**STAFF REPORT**  
**PLANNING AND ZONING COMMISSION**  
For the April 30, 2015 meeting

**TO:** Planning and Zoning Commission Members  
**FROM:** Sheena Danzer, Planning Director  
**SUBJECT:** Site Plan Review for Windsor Crossing Senior Living Facility

**ENGINEER REVIEW**

GRADING/UTILITY  
SHEET 3 OF 3  
A1700

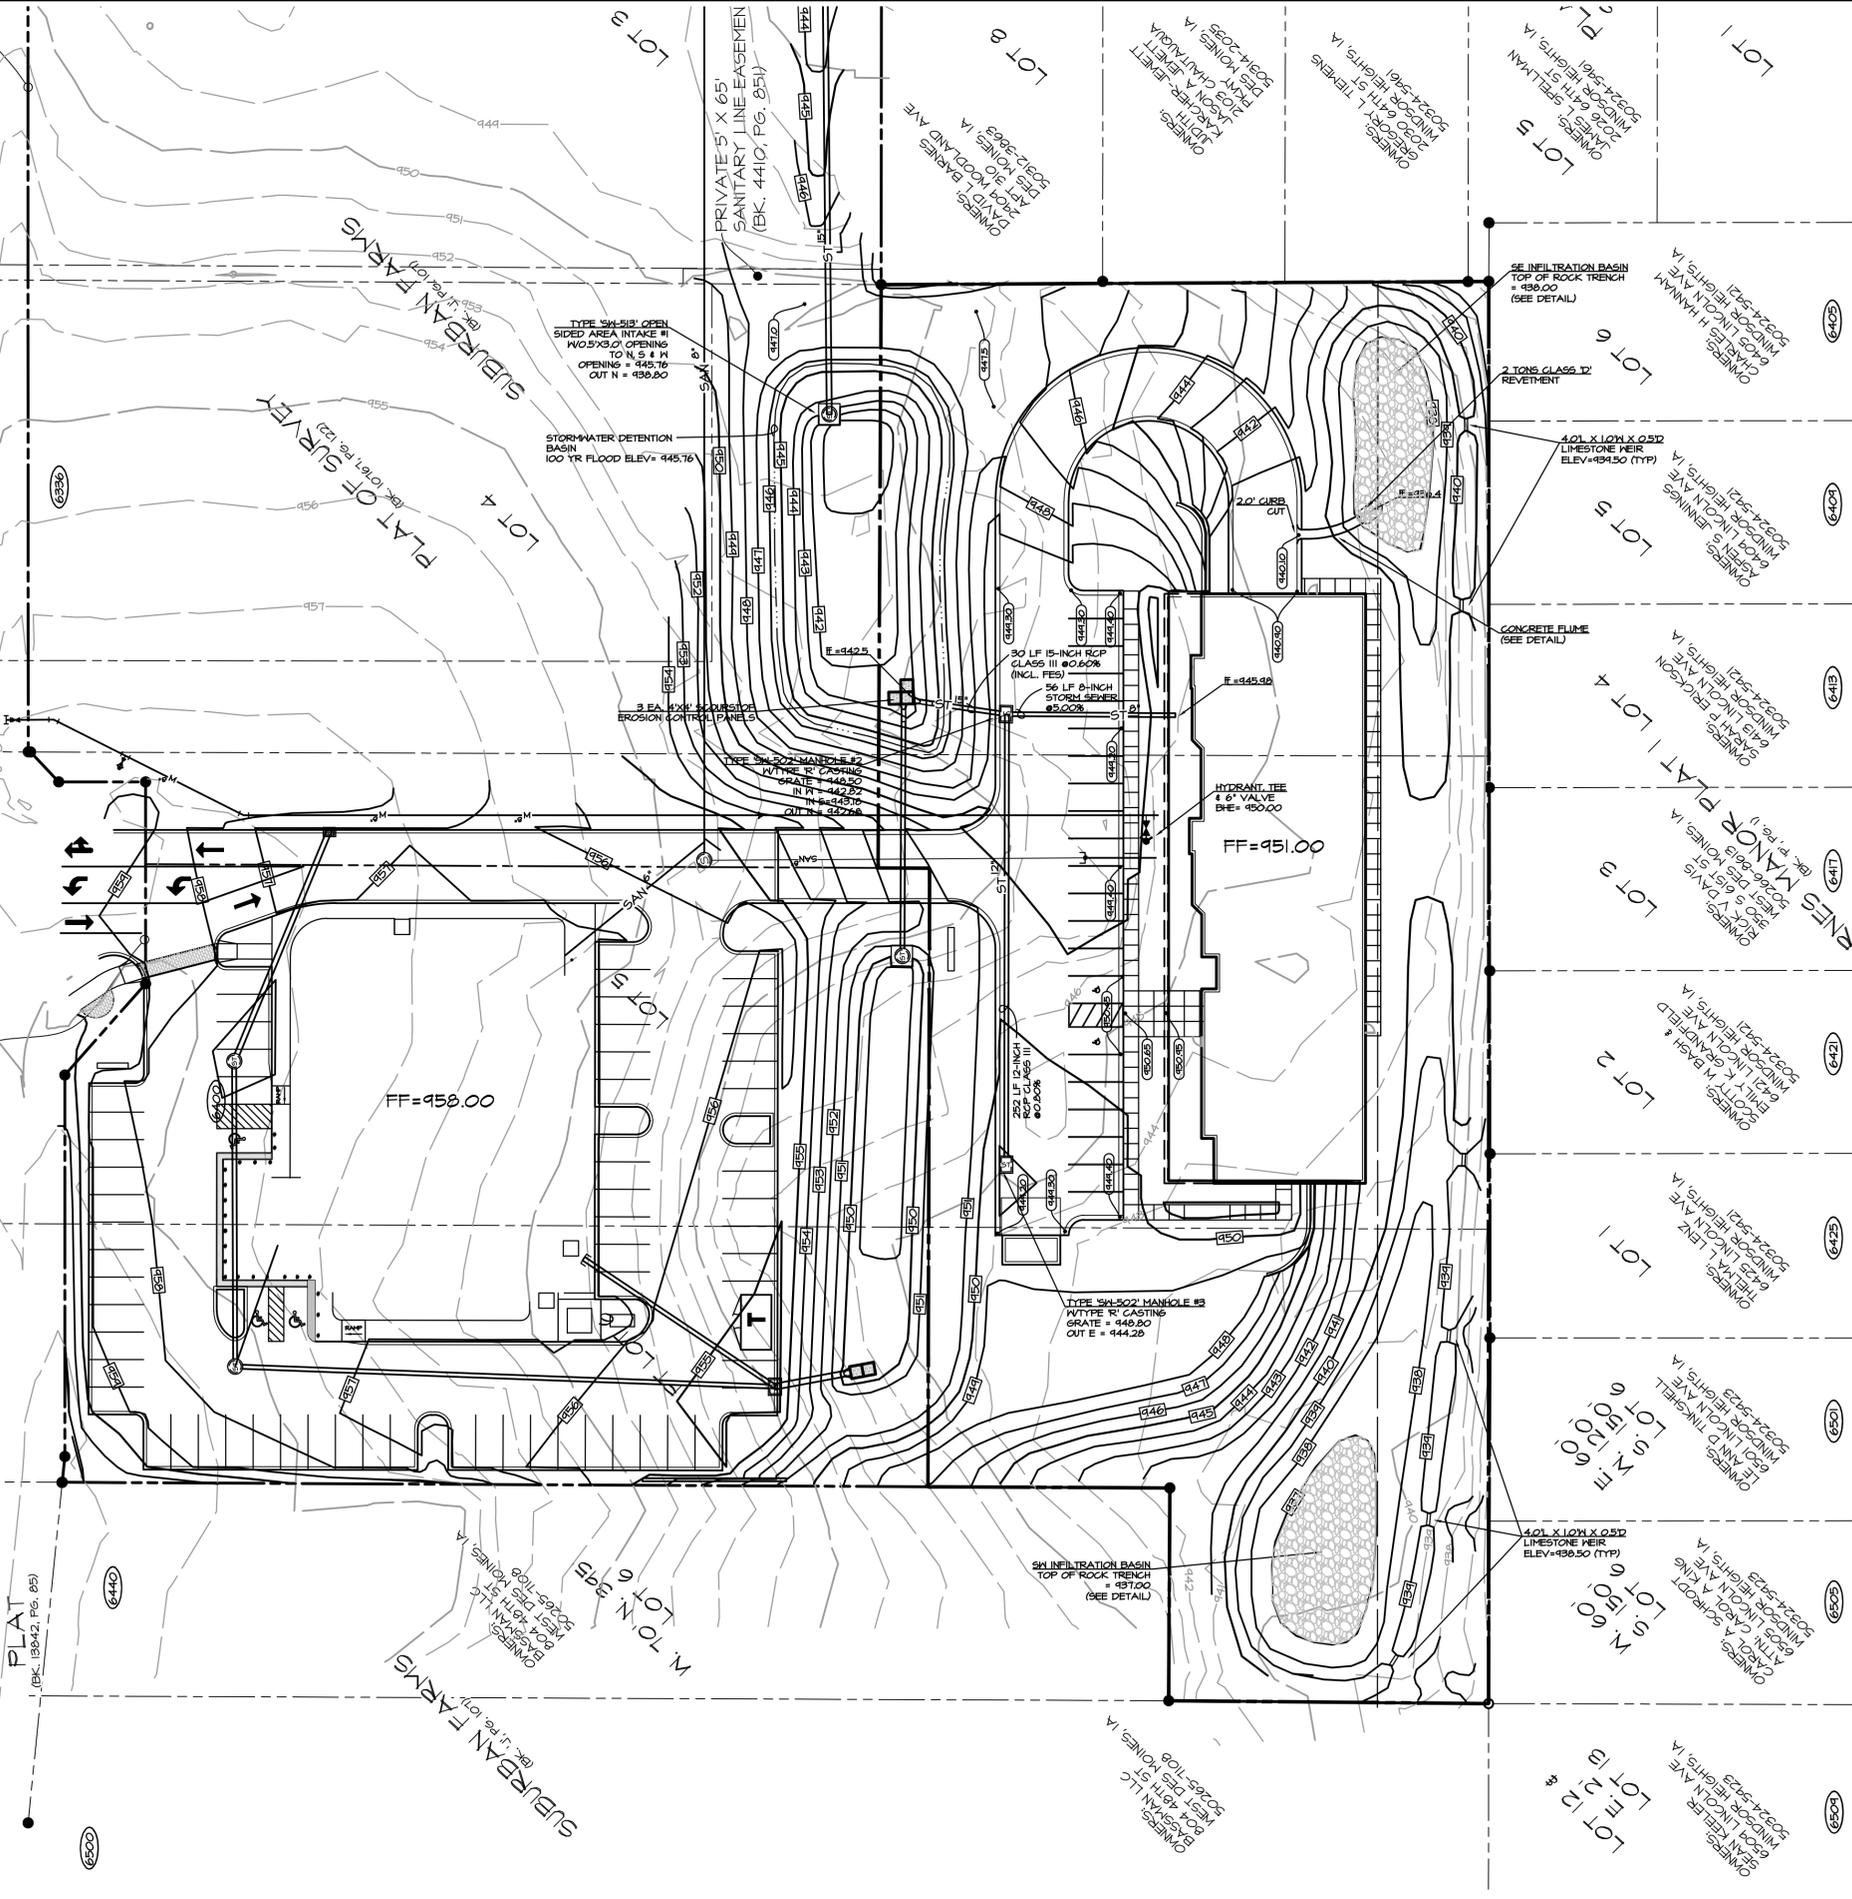
- Need a copy of the storm water calculations.
- North arrows need correcting (sheets 2 and 3) as to not confuse PnZ or Council on orientation
- Need to see construction details for permeable pavers, parking lot and walks etc.

- There appears to be no outlet for the two retention areas south of the building.
- What materials will be used to construct the retaining walls?
- If the intake gets plugged at the bottom of the ramp, need to know the flooding will not enter the parking in the building.

- Flows along the NW property line used to sheet flow, now are swaled along the property line.
- East and west elevations do not show retaining walls.
- Will the west retaining wall have a rail near the building adjacent to the walk?

- The northeast intake in the parking north of the building has a grate of 948.5 but no 949 contour is shown between that and the 950 to the west
- What lighting is being proposed in the parking lot?

DIMENSION/LANDSCAPE

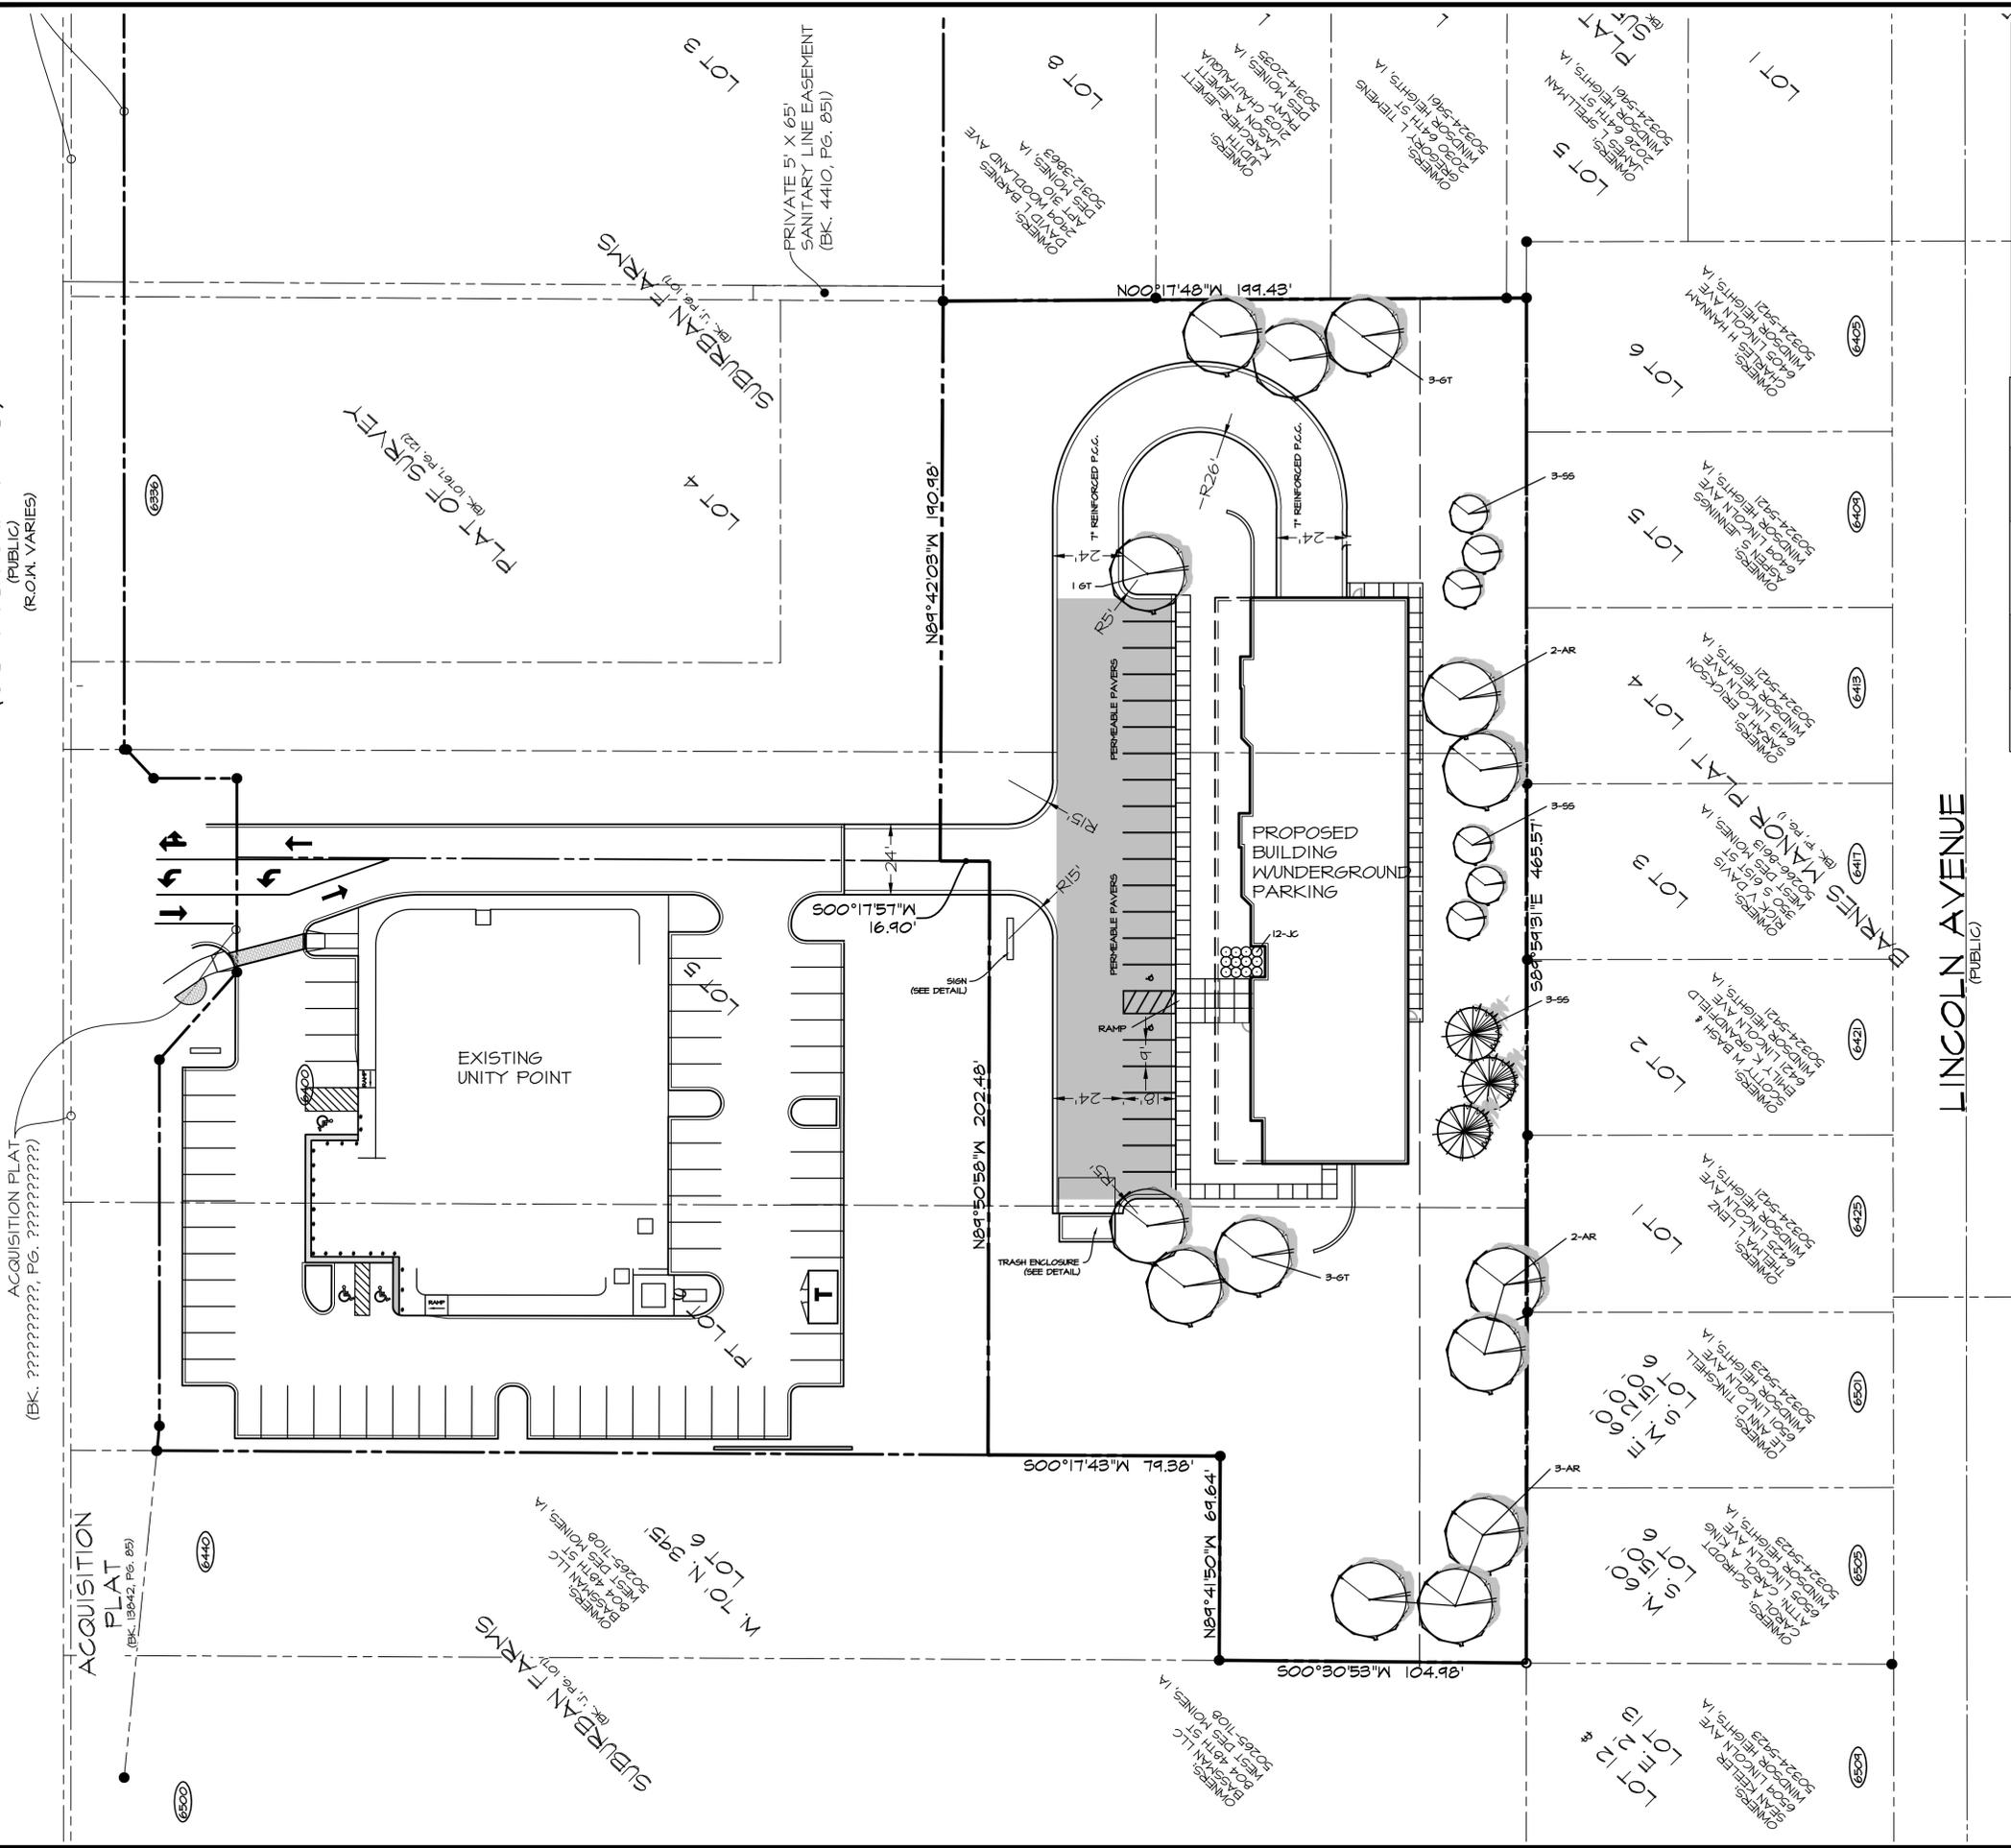
- Looks like a water service easement will be needed near Hickman Road.
- I believe the scale is incorrect on the two site plan drawings.
- The drive ramp may need to be widened to accommodate head to head traffic on the curve.
